Illustrated Parts List - IPL Update

H562XP/XPG

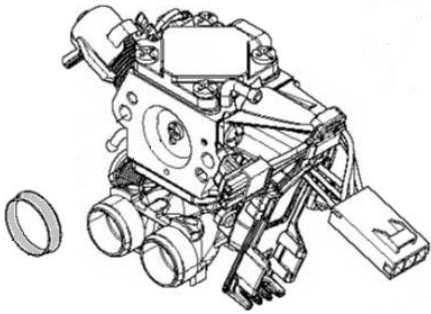
1. New Inlet pipe, assy 583 96 41-03/-04 have been introduced. The change has been made to ensure the assembly and to avoid leakage.
2. The New Carburetor, kit 501 46 33-05 consist of: New Carburetor ZAMA140058A, a separate support sleeve 582 02 51-01 and AT-instruction.
3. New article number and some minor changes on Air Nozzle due to change of supplier.

1. Carburetor

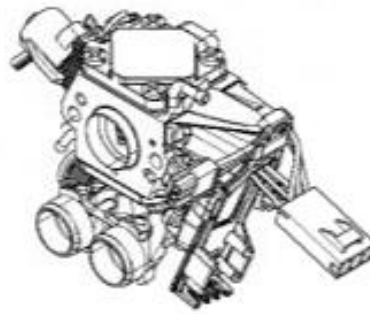
New version

501 46 33-05, ZAMA140058A

Old version

501 46 33-03, ZAMA140055A
